HS2

Yarnfield and Cold Meece Parish Council, Stone Town Council and Chebsey Parish Council

HS2-HOL-023

Petition paragraph 3.1 – Aldersey's Rough

Construction traffic histogram Yarnfield Lane east of the HS2 Phase 2a alignment

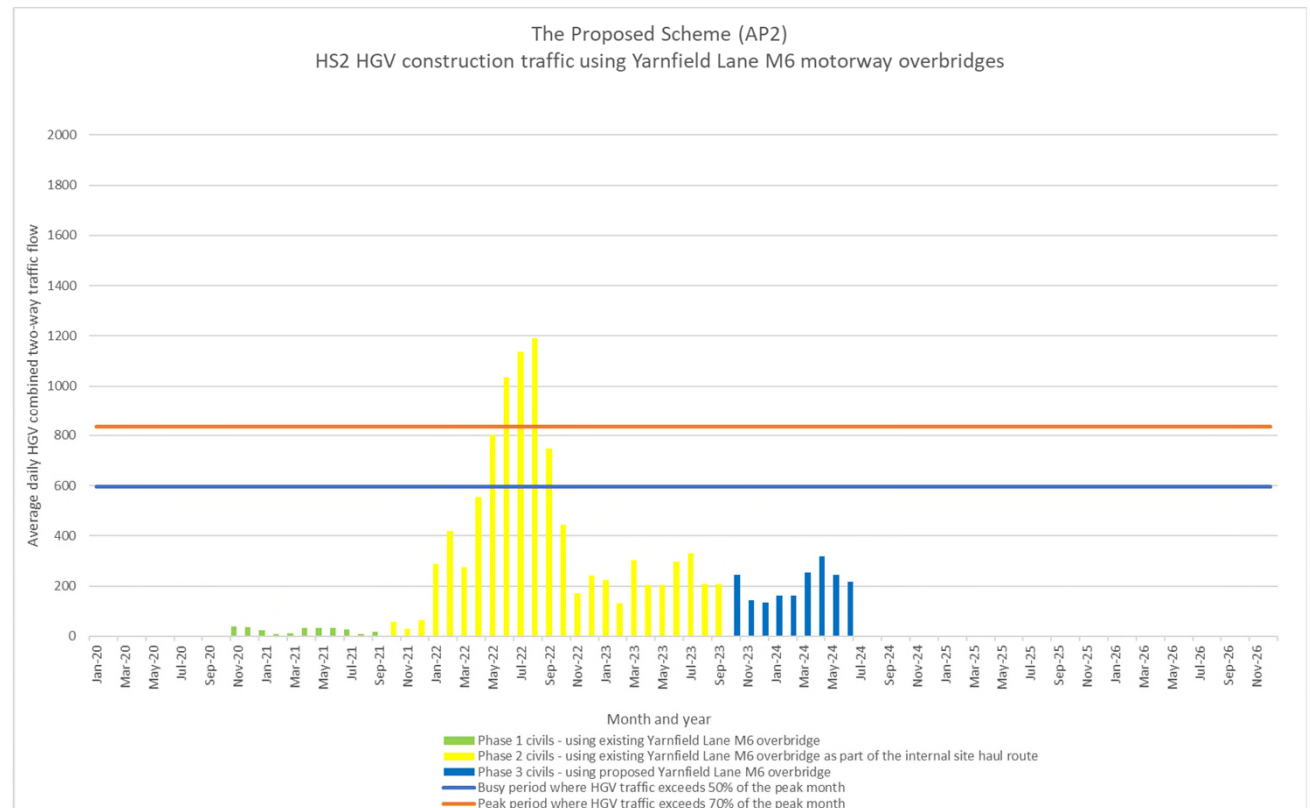
In Phase 2 all HGV construction traffic uses the existing bridge which will become part of the site haul route network. Public traffic will use the proposed realigned Yarnfield Lane M6 overbridge. The busy and peak period of traffic occurs during Phase 2.

During Phase 3 the average daily combined two-way HGV flows during the peak month is 318 HGVs.

Combined HGV construction traffic histogram on Yarnfield Lane, east and west of the HS2 Phase 2a alignment

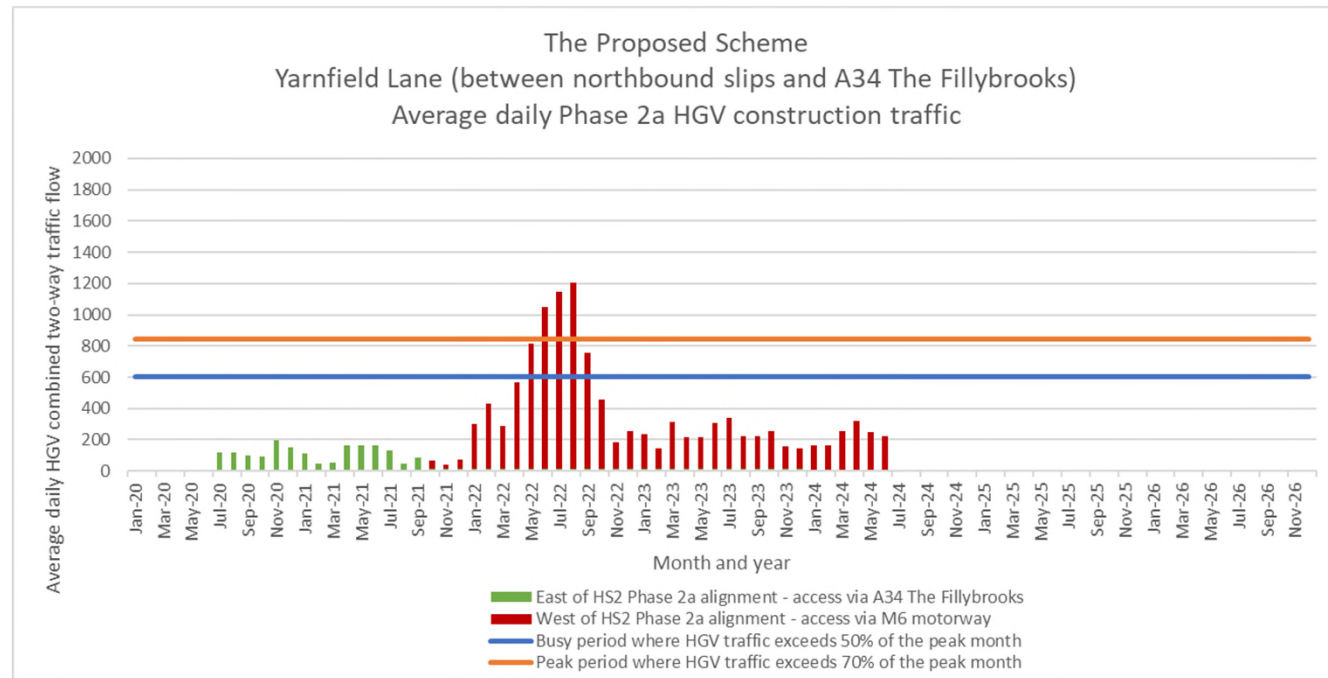
This histogram is a combined HGV construction traffic histogram for all HGV movements on Yarnfield Lane (including existing and proposed) both east and west of the HS2 Phase 2a alignment.

It shows that the average daily combined two-way HGV flows during the peak month is 1204 HGVs. The peak period duration (where HGV traffic exceeds 70% of the peak month flow) is three months and the busy period (where HGV traffic exceeds 50% of the peak month flow) is five months.

Figure 5 Plan of IMB-R showing indicative ground treatment areas (shown in orange) in the AP2 design (areas assessed from desk study data and subject to confirmatory HS2 Preliminary Ground Investigation).

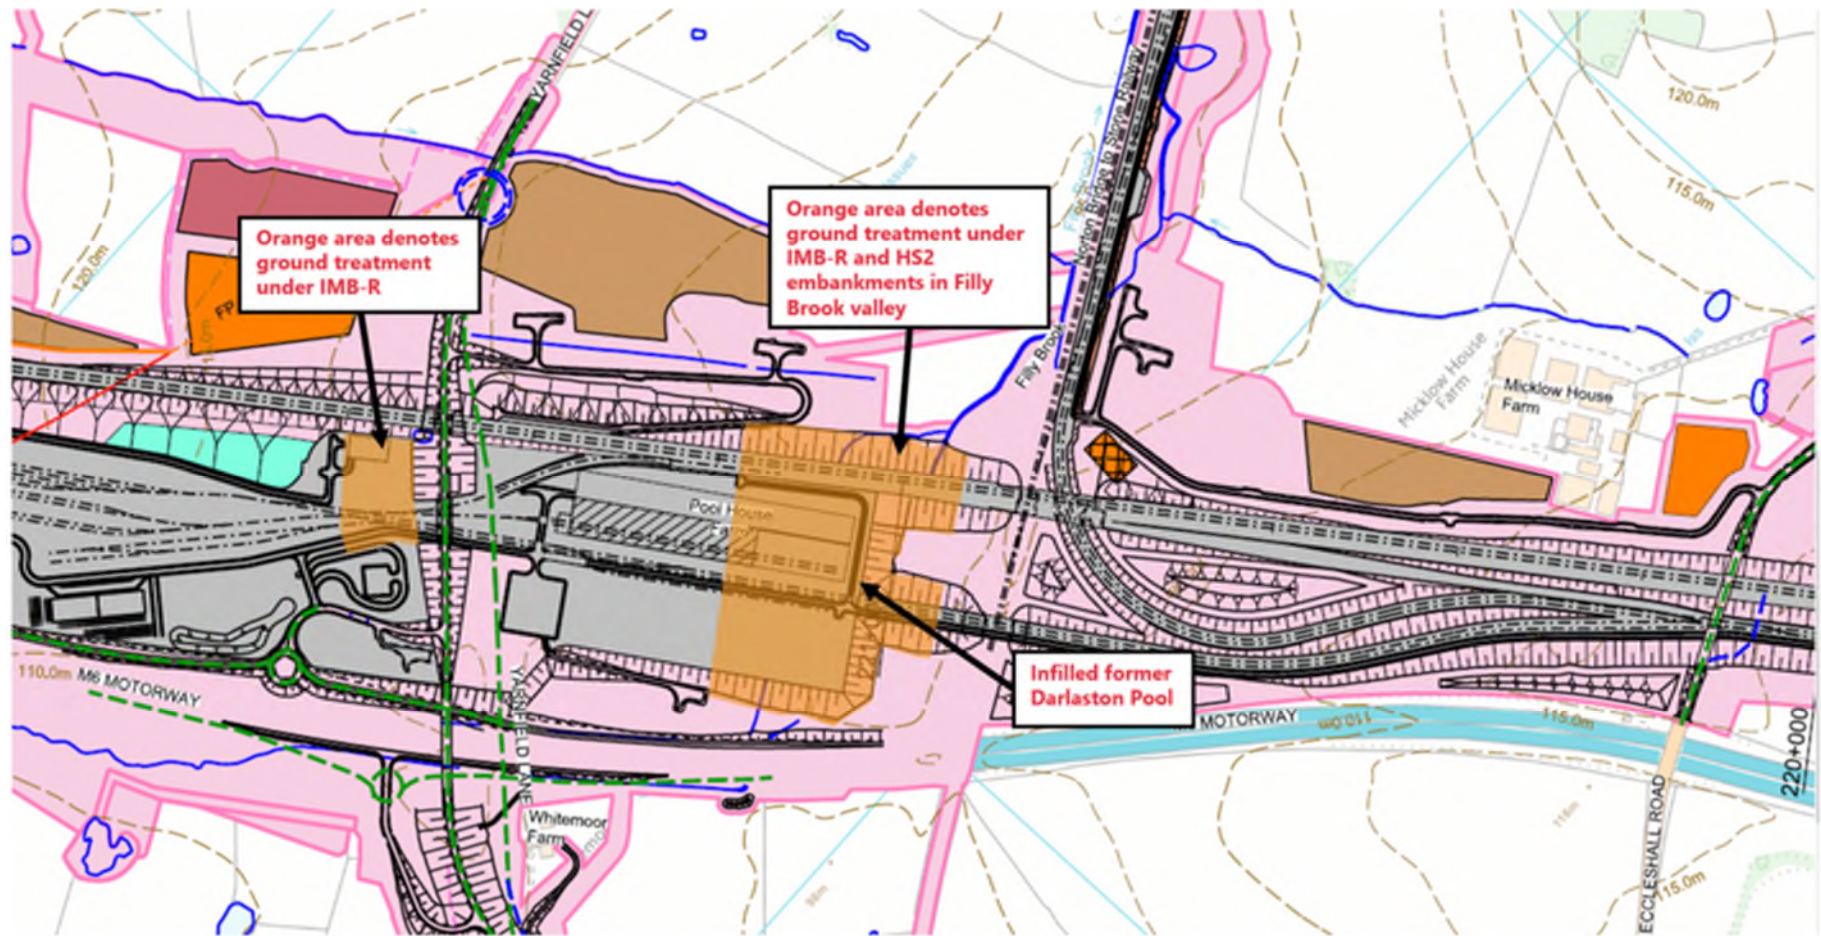
- 4.2.2 The ground treatment within the IMB-R earthworks design principally comprises two main areas (see Figure 5) as follows and would be carried out by excavating the soft ground and replacing it with high quality granular material:

The draft PGI has confirmed that the excavate and replace ground treatment method is suitable for areas away from the part of the Filly Brook valley near Pool House Farm, where the soft ground deposits have been confirmed as being up to an average of two metres thick.

The draft PGI has confirmed artesian groundwater conditions and a greater thickness of soft ground in the Filly Brook valley near Pool House Farm. In this area an in-situ ground improvement method would be a more appropriate ground treatment method than the excavate and replace method originally proposed in the AP2 design.

Figure 6: Sketch Cross-section through IMB-R embankment and adjacent HS2 railway embankment showing embankment materials and ground treatment

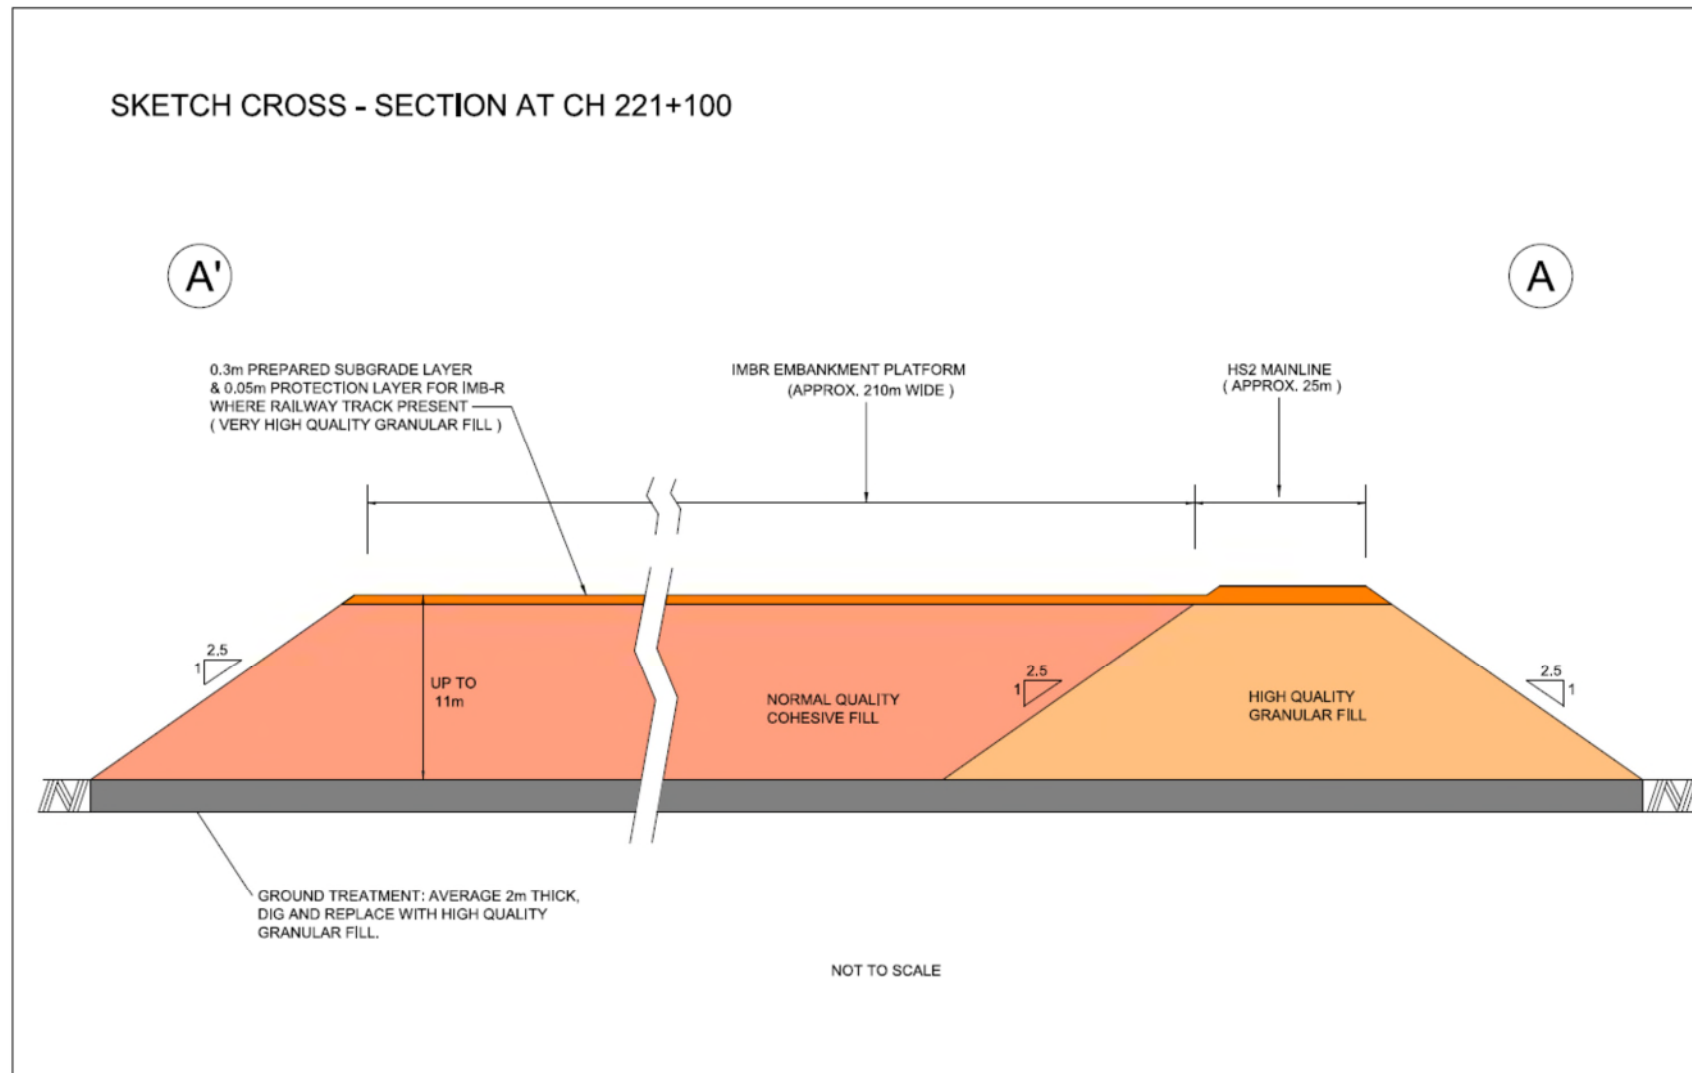
- 4.2.8 As low train speeds are anticipated at the Stone IMB-R and the Stone Headshunt, the AP2 design assumed that the embankments for the Stone IMB-R and the Stone Headshunt would be built out of normal quality cohesive material (see Figure 6) rather than the high quality granular material required for embankments where the train speeds will be higher, together with the associated highways and access tracks.

- 4.2.12 In the AP2 design for the Stone Headshunt and HS2 mainline, there would be 0.5m thick prepared subgrade layer and a 0.2m thick protection layer under the railway tracks. These would both be very high quality granular materials and it has been assumed that they cannot be site-won and would need to be imported from external commercial quarries.

Figure 3: Cross section AP2 Yarnfield Lane M6 Overbridge Design

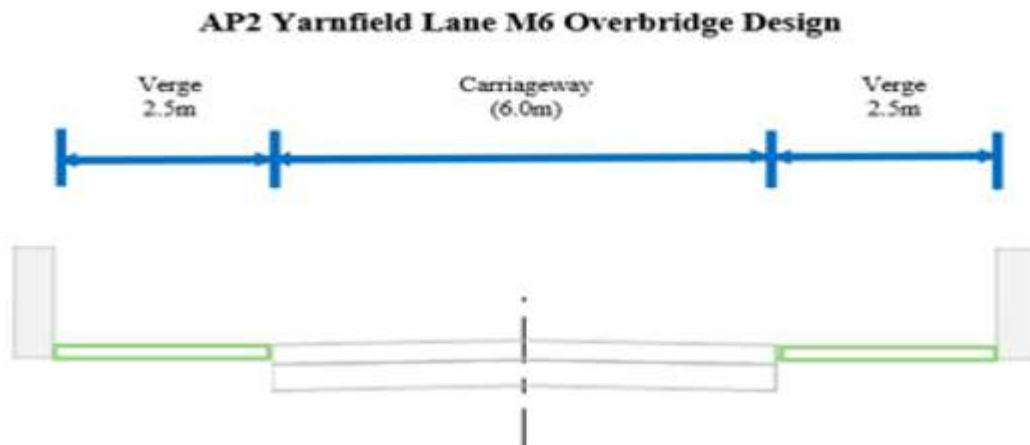
- 6.7.5 The cross sections proposed for the new Yarnfield Lane Realignment at the new Yarnfield Lane M6 Overbridge and the IMB-R/HS2 underbridges are shown in Figure 3 and Figure 4.

114 Subject to the approval of the detailed design by the highway authority, Yarnfield Lane overbridge will be widened to ensure the safety of all users. At detailed design HS2 Ltd will work with the highway authority to determine appropriate lane widths for road users to cross the Yarnfield Lane overbridge and the Bill includes the powers required to change the width of the bridge to accommodate the required lane widths.

The Promoter has further confirmed to the Petitioner, through additional information provided on 11 March 2020, that there is adequate land included within Bill limits to ensure the safety of all road users.

Figure 5: Junction visibility - IMBR connector road approach to the new Yarnfield Lane

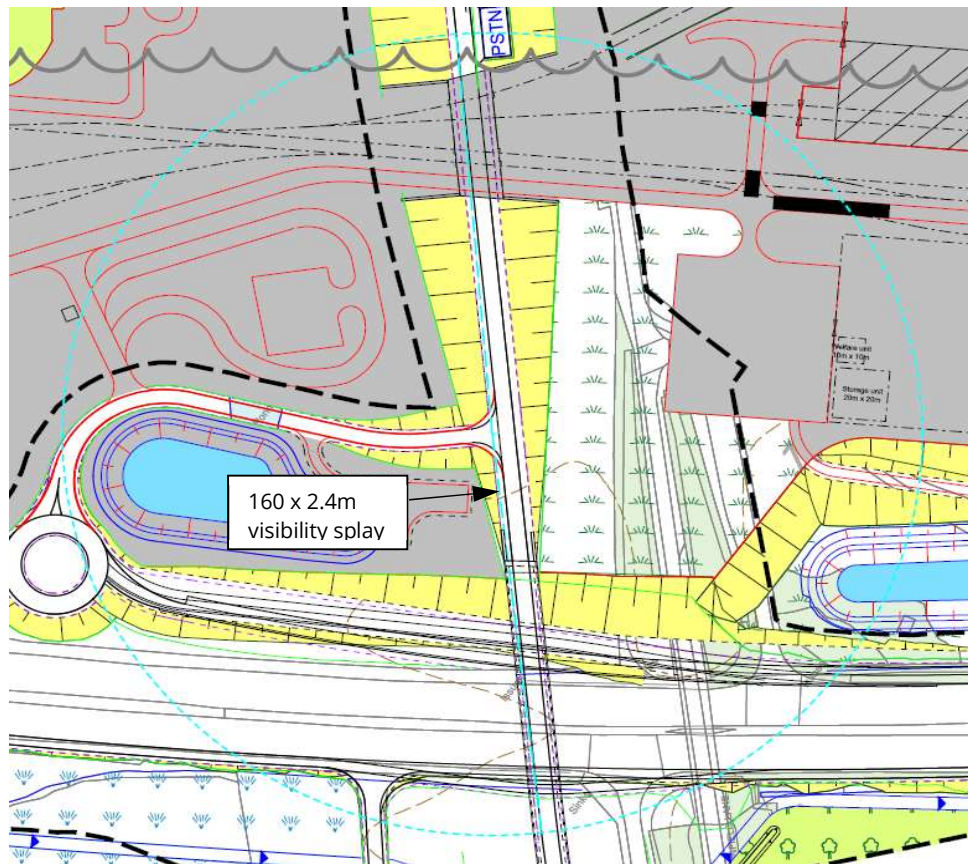
- 6.11.1 A design speed of 85kph was assumed for the new Yarnfield Lane realignment. In accordance with TD42/95¹⁴ this design speed requires a minimum stopping sight distance of 160m for junction visibility from the IMB-R connector road approach to the new Yarnfield Lane Realignment. Figure 5 demonstrates that the 160m x 2.4m required junction visibility splays are achieved in the AP2 design. The junction visibility is therefore compliant with TD42/95.
